Scope of work for KIF Engineering Peer Review of Coal Byproduct (Gypsum and Ash) disposal plans:

Weekly Progress Summary
TVA - Kingston Fossil Plant and John Sevier Fossil Plant Sevier Projects
GeoSyntec Project No. GR3471

KINGSTON PROJECT (Peer Review)

**Introduction of Alternative Ash and Gypsum Disposal Strategy
Kingston Fossil Fuel (KFF) Plant
GeoSyntec Consultants
22 October, 2004**

Interface of Gypsum with the 60:40 mix

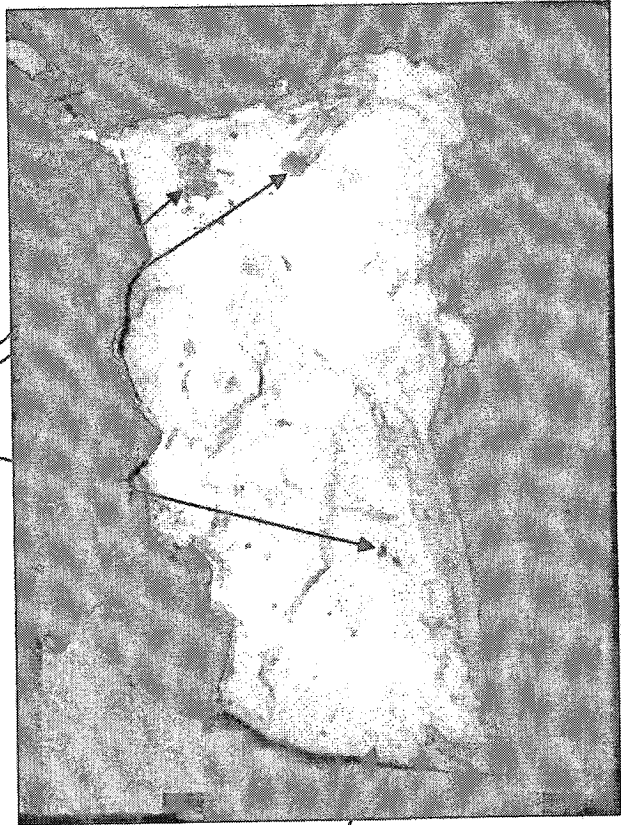
Attached is closeup photo of the interface between the Gypsum and 60:40 mix.
Absolutely no particle movement from the Gypsum into the 60:40 mix.

The 60:40 material did float up into the Gypsum slurry as the Gypsum was deposited

Note: There is no movement of Gypsum into the 60:40 layer

Figure 1.
Plan View

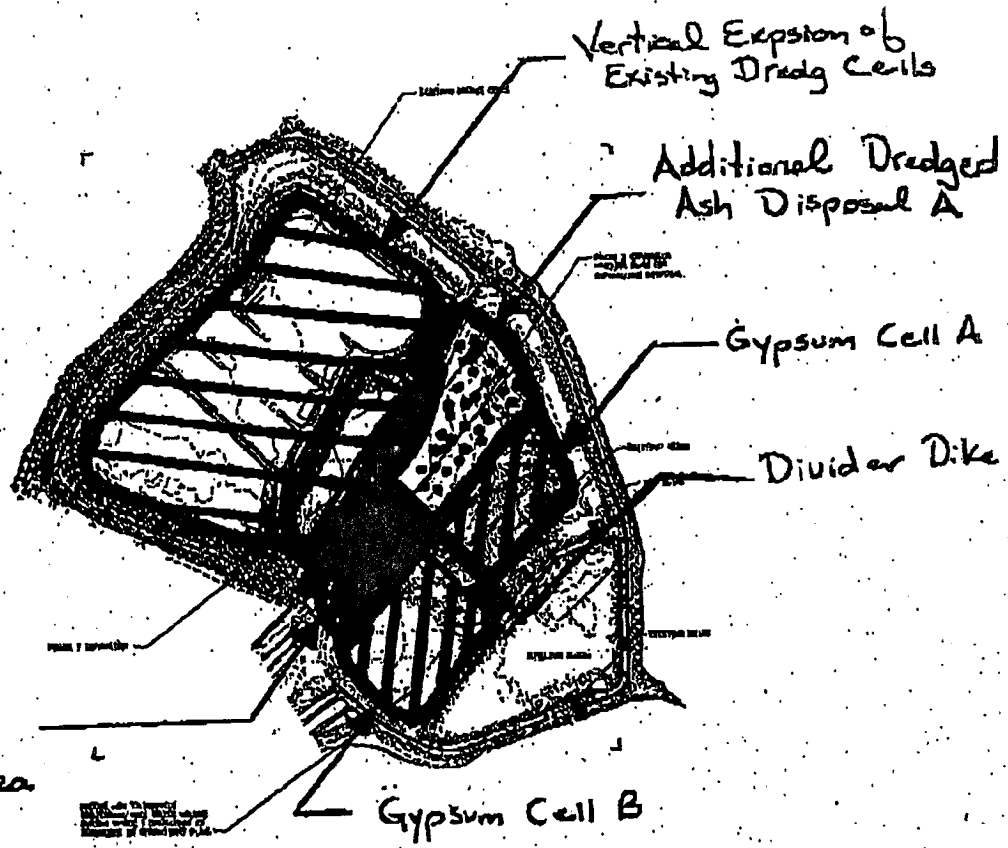
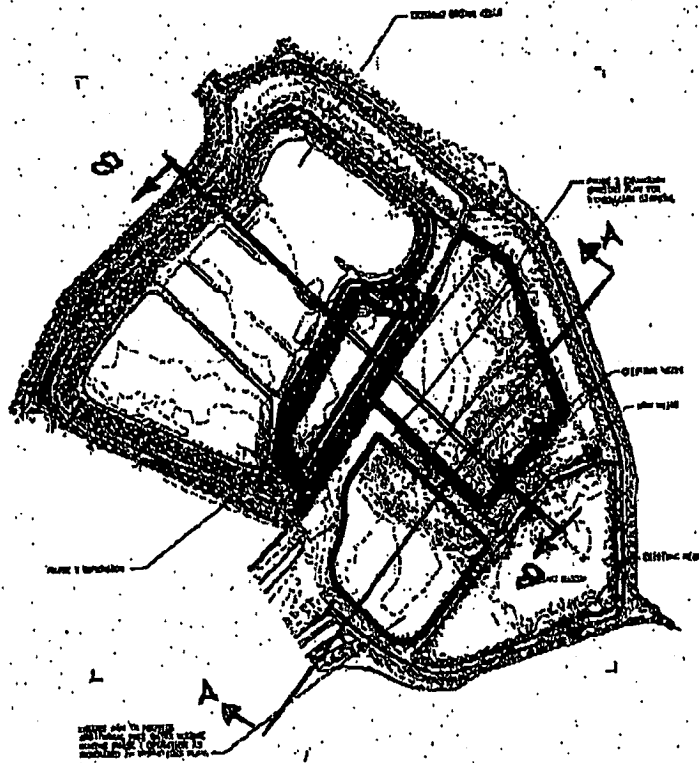
- **Relevant Figures:** Please reference Figures 1 (Plan View), Figure 2 (E-W Cross-Section), and Figure 3 (N-S Cross-Section), each one displaying currently proposed option at the top of the page and the alternative option at the bottom of the page.

- **Vertically Expand Existing Dredge Ash Disposal Area:** Increase disposal capacity of existing dredge cells by controlling water levels within ash using toe drain network, to allow vertical expansion of cells at current 4H:1V side slope geometry to achieve approximately 3M yd³ (minimum) of additional ash disposal capacity.

- **Develop Gypsum Storage Basins:** Develop southern end of existing ash pond into a conventional two-pond gypsum disposal area using rim ditch and sequential filling techniques, while maintaining "valley" between this gypsum disposal area and the existing dredge cells as a conventional ash pond for as long as possible, possibly using eastern side for a dredge ash staging area as needed.

- **Stability of Existing Dredge Ash Disposal Areas:** It appears that the recent pond instability was caused by locally high water levels in the dredge cells. If the water levels can be controlled, then it appears that the height of the existing cells can be increased significantly. The assumed properties of the ash used in stability analyses are reasonable. Based on these shear strength properties for the fly ash and the currently constructed side slopes, adequate short- and long-term stability can be controlled by the selective use of a network of toe drains that is incorporated into the design.

Figure 2.
Section A-A
Across
Gypsum
Ponds

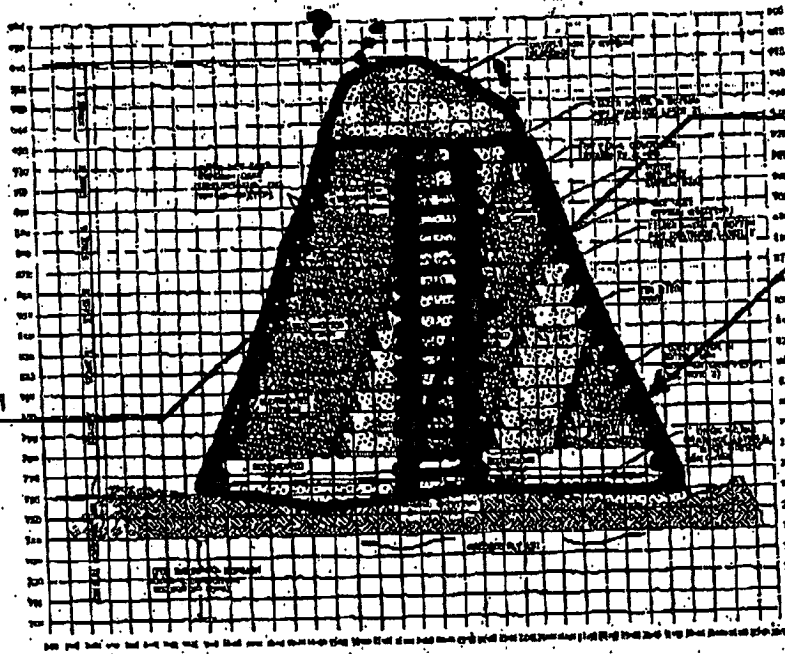
- **Stability of Gypsum Basins:** Under the alternative plan, the gypsum ponds will be constructed, filled, and managed using conventional gypsum disposal techniques and will incorporate side slopes no steeper than those currently proposed. Since the gypsum is inherently stronger than fly ash, the gypsum monocell design will be inherently more stable than the current proposed design.

- **Site Operations - Gypsum:** The alternative strategy incorporates a "conventional" gypsum disposal technique including construction via two sequentially operated, large surface area monocells. Gypsum distribution and sedimentation and the subsequent dike construction will incorporate perimeter rim ditches. From an operational perspective, this technique is significantly easier than the currently proposed technique.

Figure 3.
Section B-i-3
Across
Dredge
Pond and
Gypsum
Pond

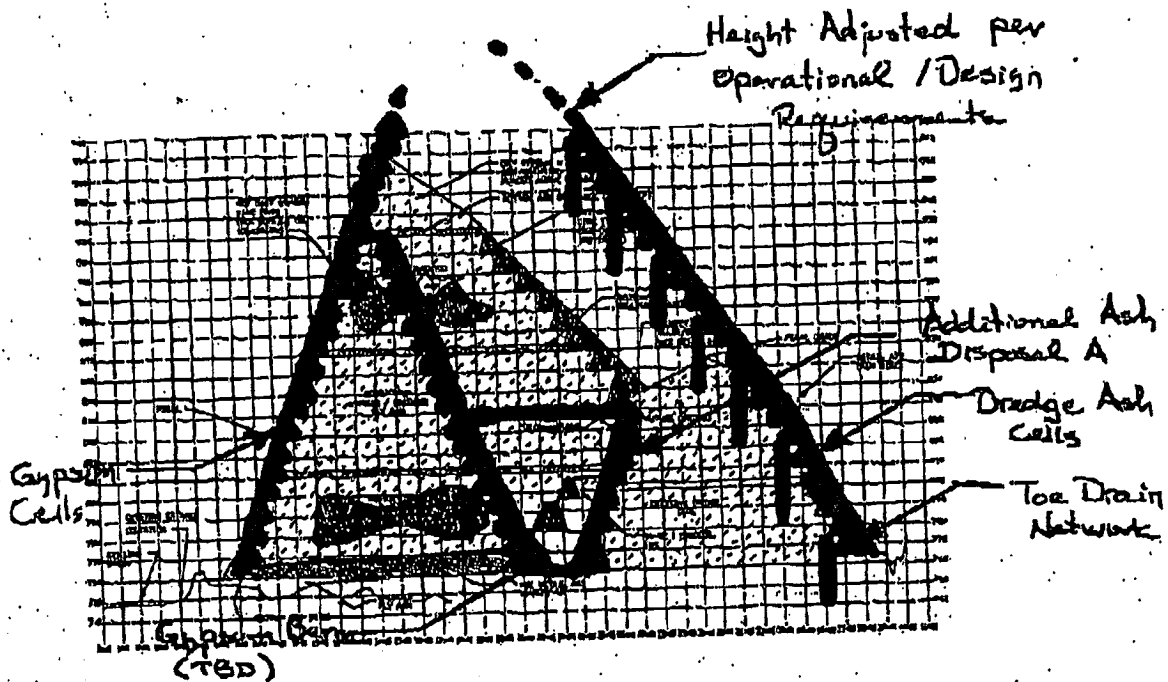
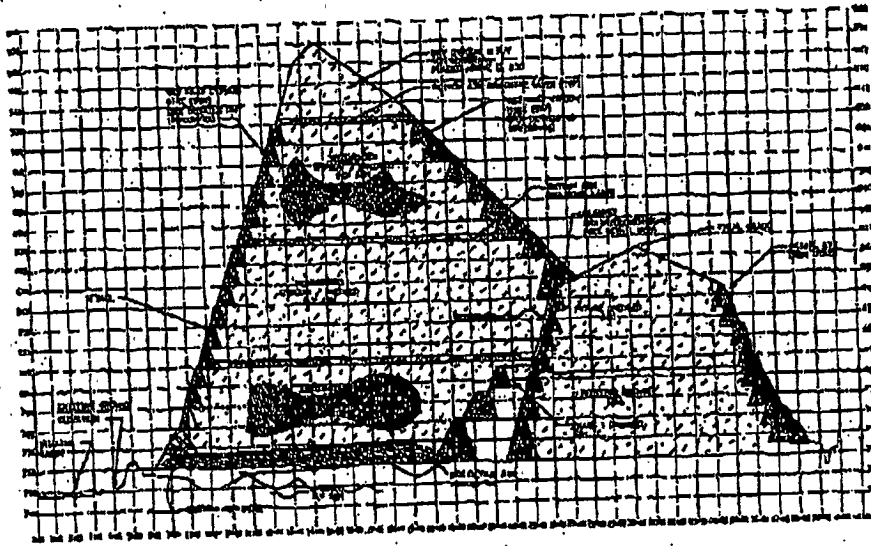
- **Stability of Dredge Ash Cells:** A detailed evaluation of the slope stability, including the appropriate use of benches and toe drains needs to be completed.
- **Volume of Ash and Gypsum Disposal Areas:** The attached figures are conceptual renderings of the alternative strategy. The footprint of the gypsum basins needs to be established based on design disposal volumes. Similarly, the size of the wet ash pond during the life of the facility needs to be assessed.
- **Surface Water and Process Water Management:** As with all gypsum and ash disposal strategies, the design of the surface water management ditches and retention ponds needs to be considered, as does the detention times materials within the wet ash pond.
